REMARKS

AMENDMENTS TO THE DRAWINGS

FIG. 4

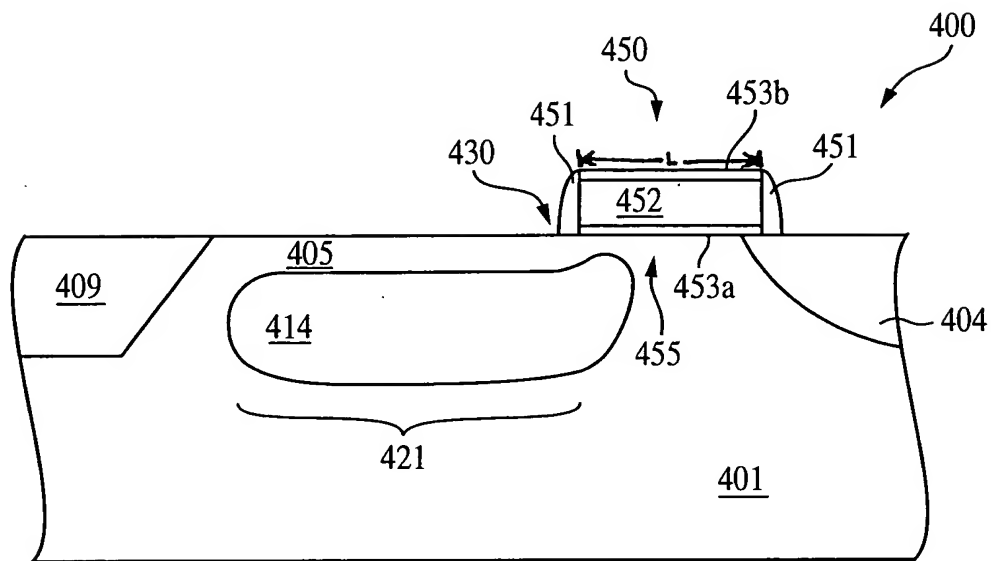
The drawings have been amended. In particular, FIGS. 4 and 6A have been amended to include the reference character L representing a length of a gate electrode. No new matter has been added.

The attached sheets of drawings include changes to FIGS. 4 and 6A as described in the "Remarks" section of this amendment. The attached sheets replace the originally filed sheets containing FIGS. 4 and 6A.
